INITIAL FIRE SAFETY INSPECTION REPORT

Ahsan Composite Ltd. (Extension 2)

RSC ID: 26156

Date: 06-Aug-2025

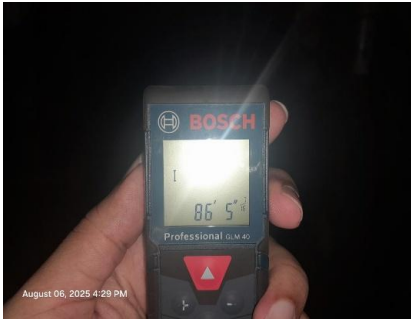
F-05	Means of Egress	Falling hazards are present at the staircase/ several lift openings located within the stair enclosures and floor areas, which are situated at a high altitude. Location: Exit Stair-3 enclosure and Lift opening inside floor area S-E side of the 5-storied Production Building-15 (Knitting Building).	Guards shall be provided at all open sides of means of egress that exceed 760 mm (30 in.) above the floor or finished ground below. New and interim: Guards shall have a minimum height of 1067 mm (42 in.). Existing: Guards shall have a minimum height of 760 mm (30 in.). Open guards shall have intermediate rails or pattern such that a sphere 200 mm (8 in.) in diameter cannot pass through any opening up to a height of 865 mm (34 in.). Guard/Handrail shall construct in accordance with RSC Technical Guidelines (Standard)¹ V1.0 Section 6.12	Within 1 month
